CONTRACT NO. 1797

OHIO RIVER TUNNEL

ADDENDUM No. 9

All bidders bidding **Contract No. 1797** shall read and take note of this **Addendum No. 9**. The Contract Documents for **Contract No. 1797 – Ohio River Tunnel** are hereby revised and/or clarified as stated below.

ORT-ST-011
NON-TBM TUNNEL INITIAL SUPPORT - TYPE 1
TUNNEL DETAILS SHEET 2 OF 4

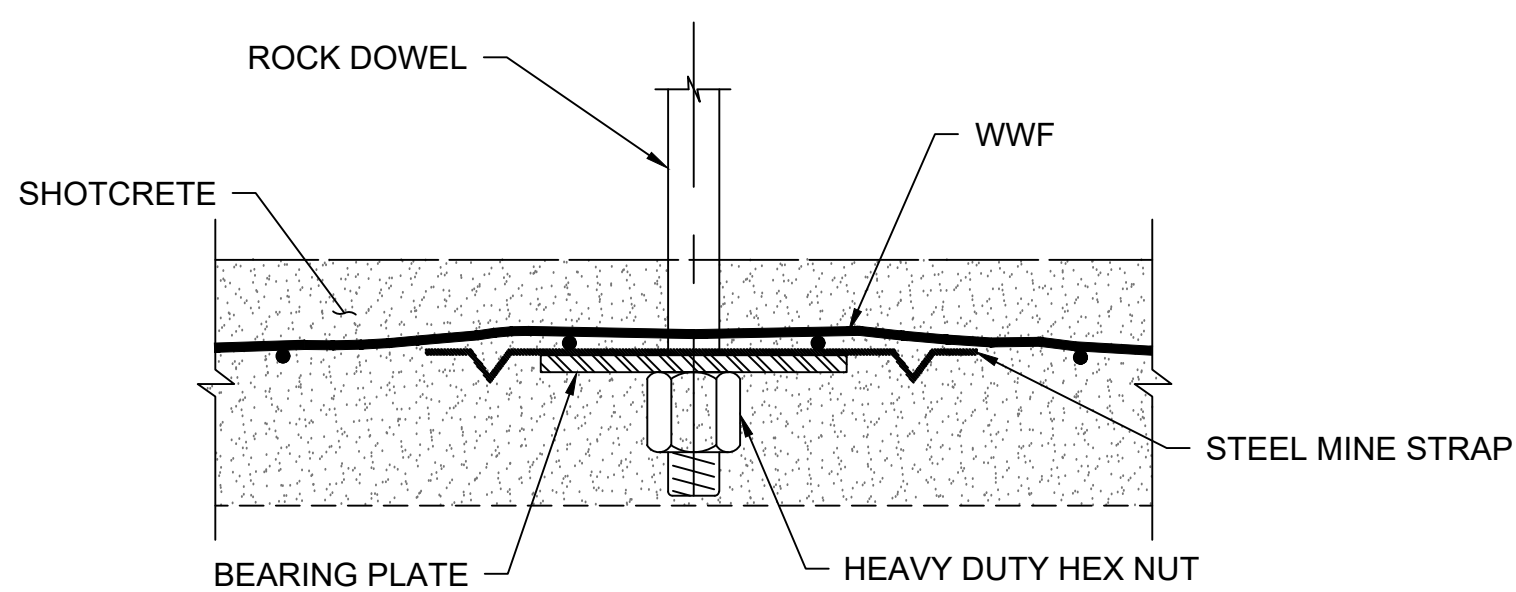
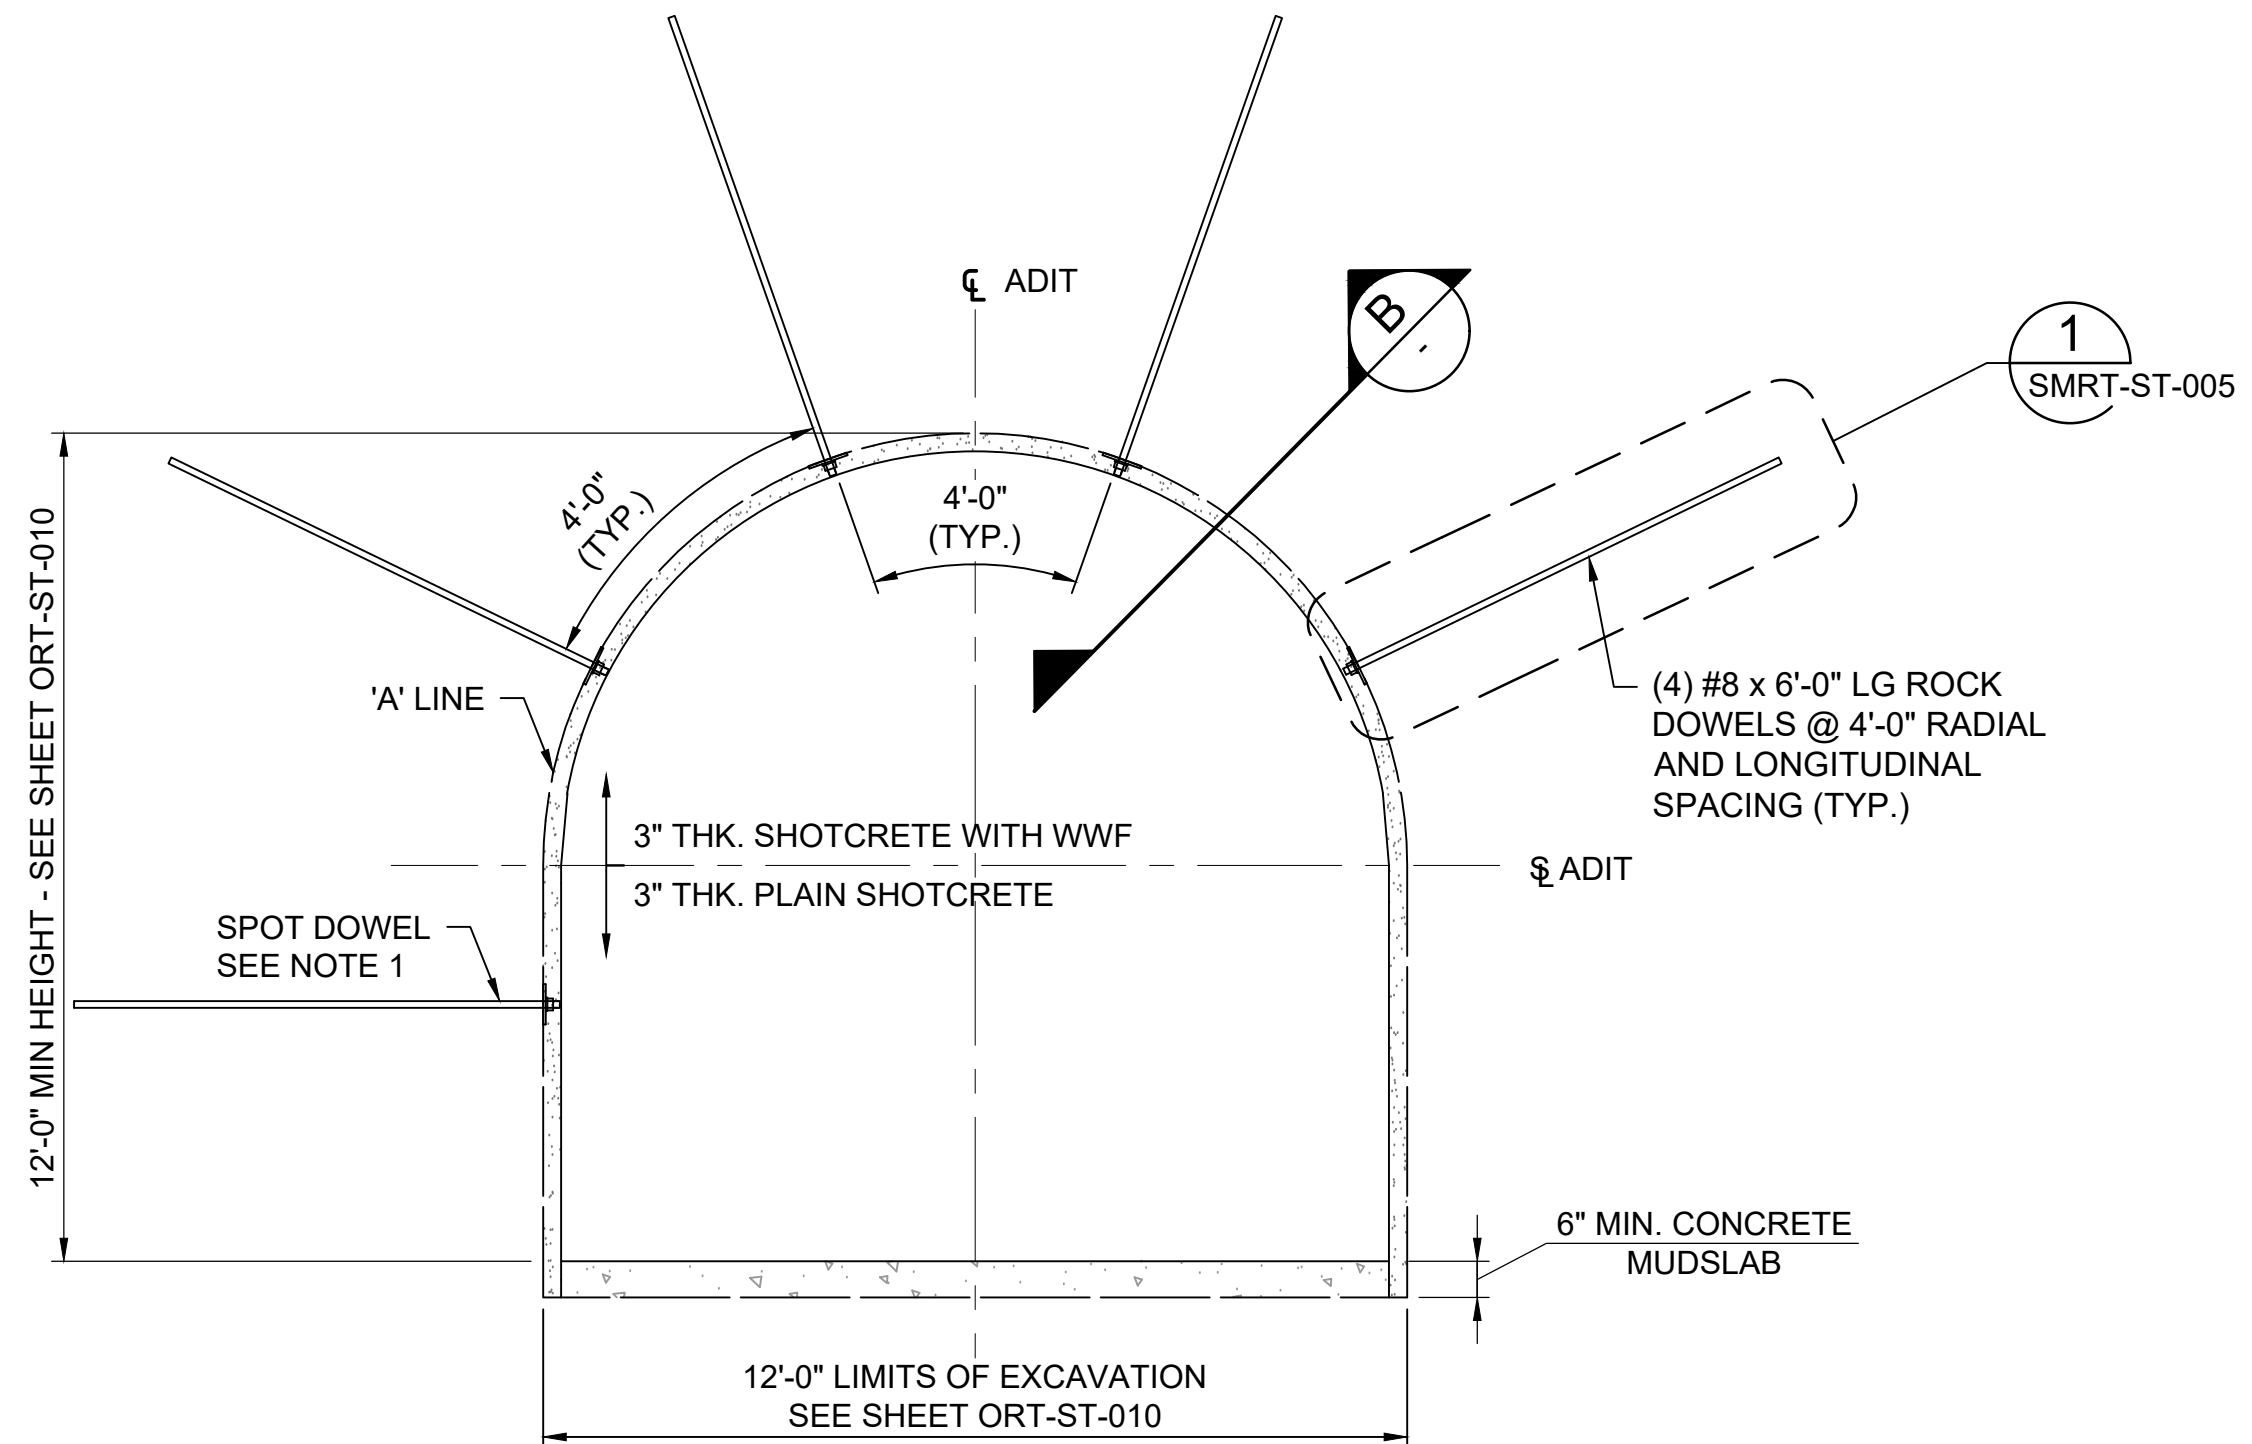
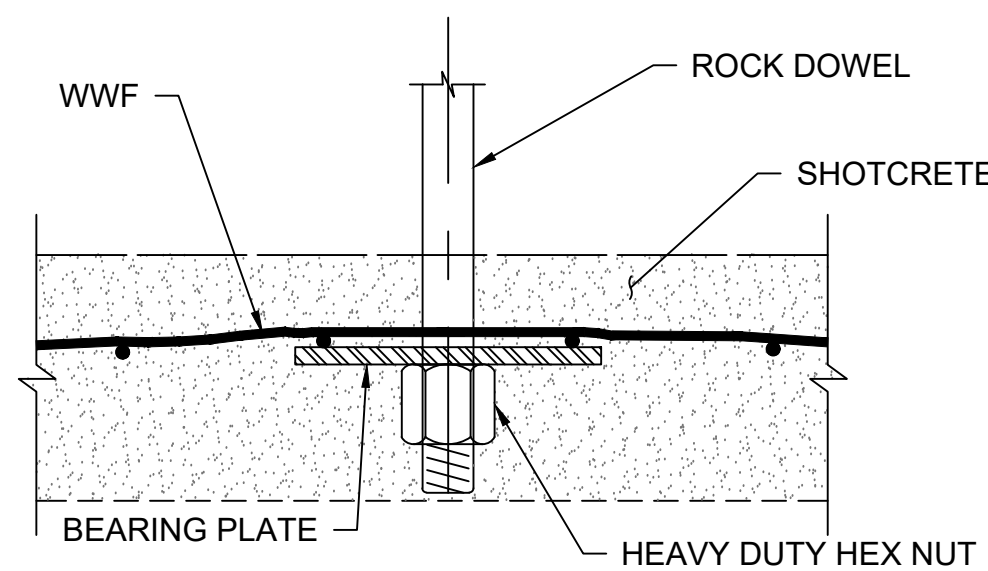
- a. DELETE ORT-ST-011 (Sheet 079 of 770) and ADD REVISED ORT-ST-011 (Sheet 079 of 770) which is Attachment A to this Addendum.
b. DELETE CCT-ST-011 (Sheet 092 of 770) and ADD REVISED CCT-ST-011 (Sheet 092 of 770) which is Attachment A to this Addendum.
c. DELETE SMRT-ST-002 (Sheet 095 of 770) and ADD REVISED SMRT-ST-002 (Sheet 095 of 770) which is Attachment A to this Addendum.
